CITY OF WICHITA

April 26, 2019

Re: BZA2019-00020: Administrative Adjustment to reduce the front setback by 20% on property zoned SF-5 Single-Family Residential.

ESTANCIA
LOT 13, BLOCK 4 (AS DEEDED)

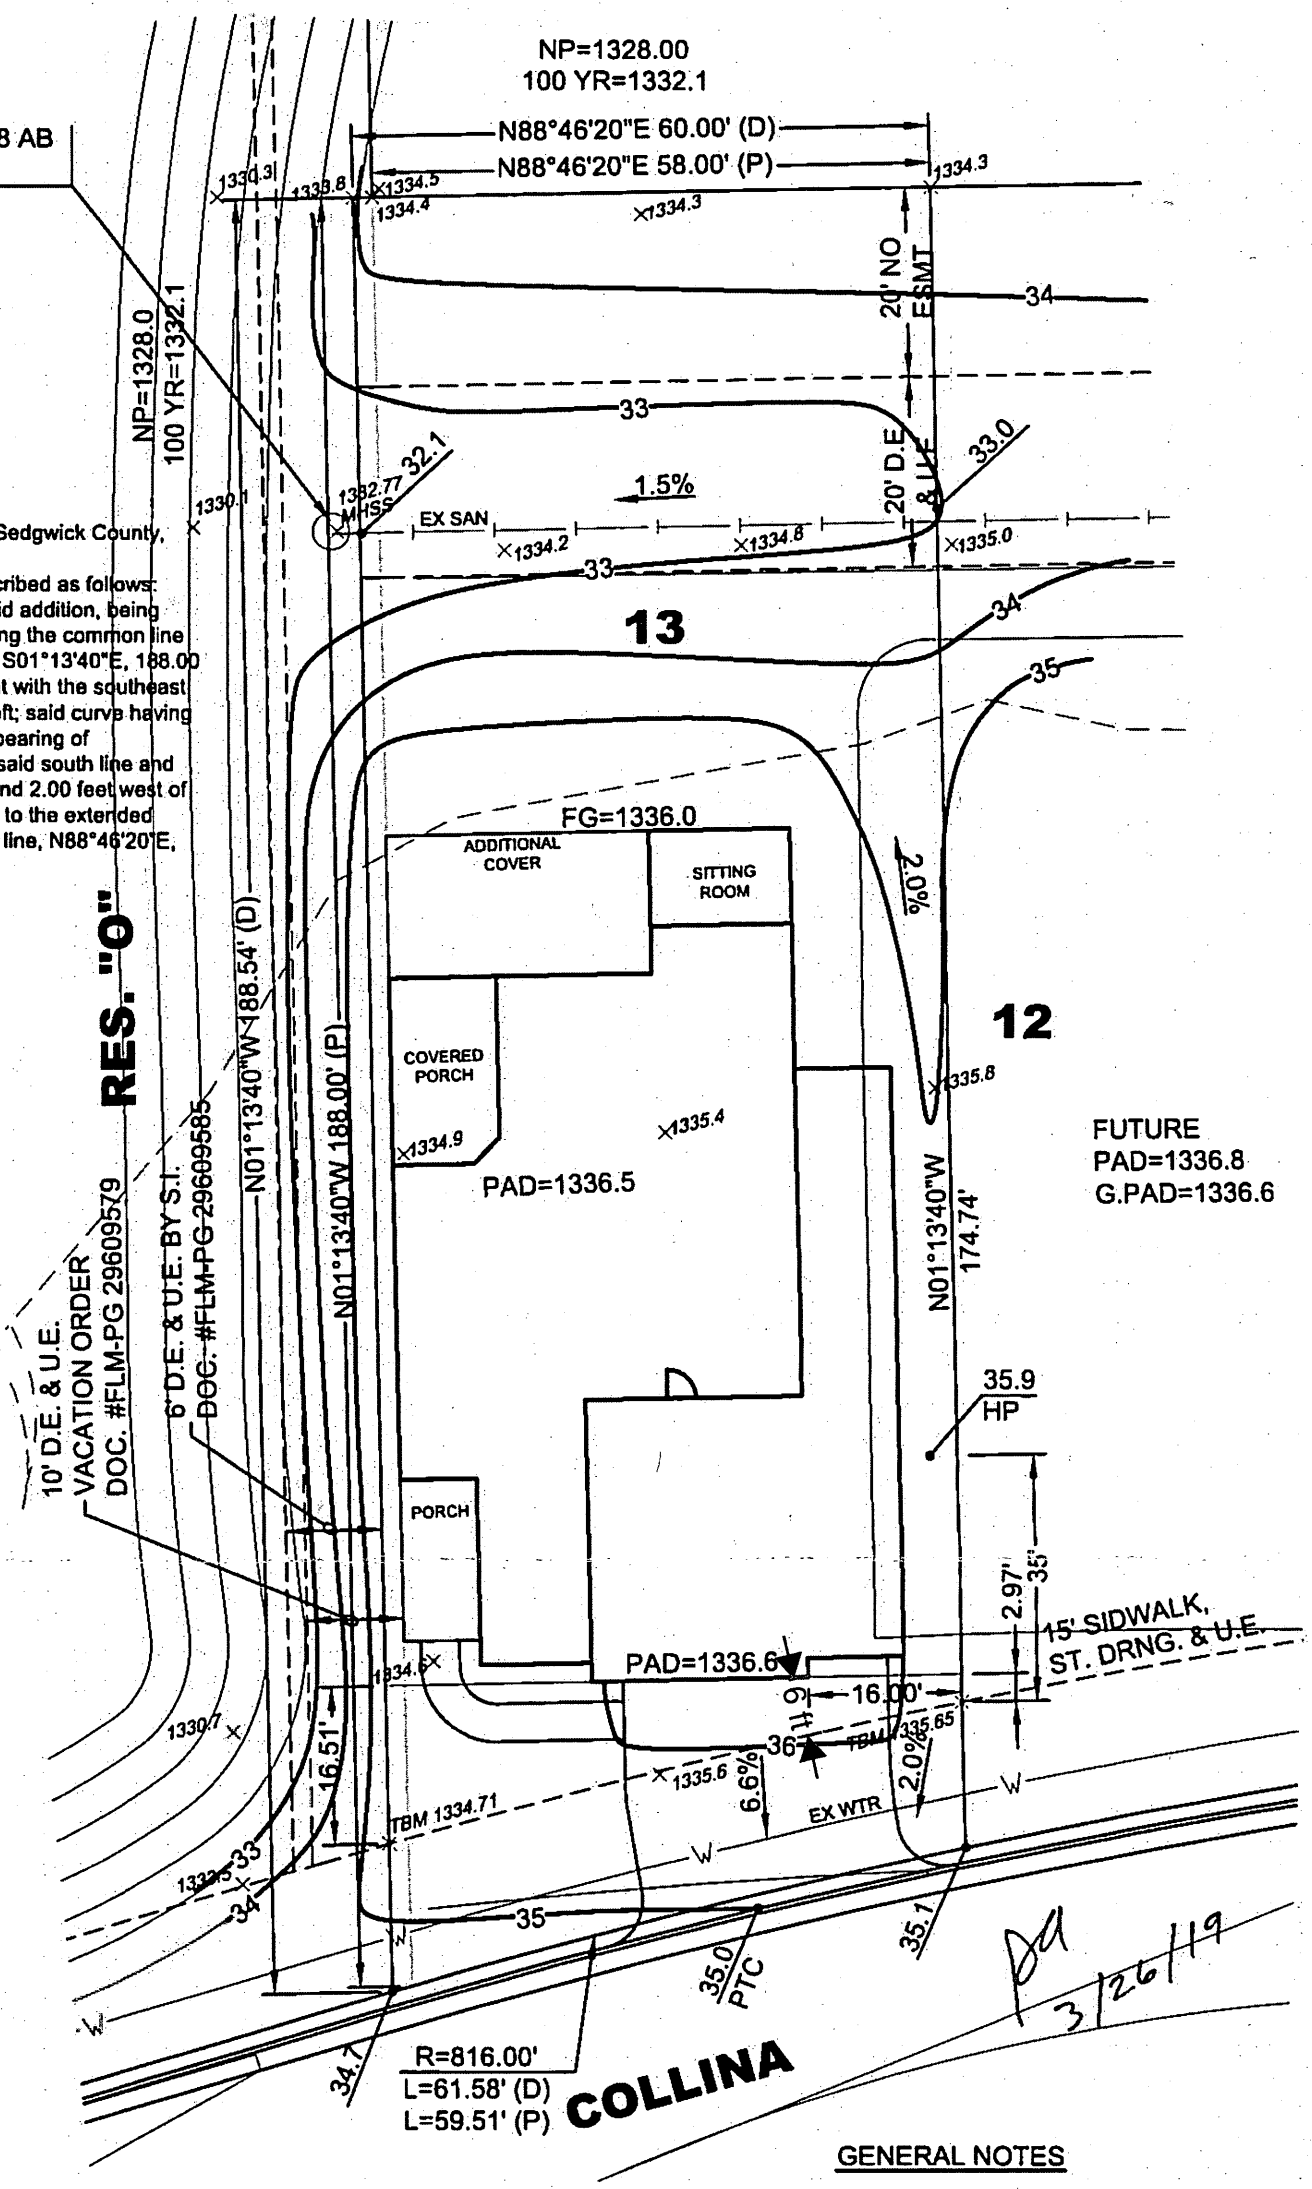
We have reviewed your request for a Zoning Adjustment to reduce the front setback on the aforementioned property. From reviewing the application, we understand that you desire to reduce the front setback from 25-feet to 20-feet so that you may build a new residence.

1) Impact on safety and convenience of vehicular and pedestrian circulation: Construction of a new residence should have no impact on the safety and convenience of vehicular and pedestrian circulation in the vicinity as right-of-way and driveways are not affected.

2) Impact on existing uses in surrounding areas: There will be no impact on the existing uses in surrounding areas as a result of the new construction; street visibility will be unchanged for neighboring properties.

3) Compatibility with existing or permitted uses on abutting sites: Abutting sites are zoned SF-5 Single-Family which allows residential development and the front yard setback reduction will not have a negative impact on existing or permitted uses.

4) Effect on public health, safety or welfare: There will be no encroachment into public utility easements or right-of-way. There will be no negative impact on the public health, safety or welfare, nor will properties or improvements in the vicinity be materially injured.

Our signatures below indicate that a Zoning Adjustment to reduce the front setback for the aforementioned property to 20-feet is hereby **GRANTED**, subject to the following conditions:

1) The site shall be developed in general conformance with the approved site plan.

3) The setback reduction shall apply only to the front setback as illustrated on the approved site plan. All other structures or additions on the subject property shall conform to the setbacks permitted by the Unified Zoning Code unless a separate Zoning Adjustment or Variance is granted.
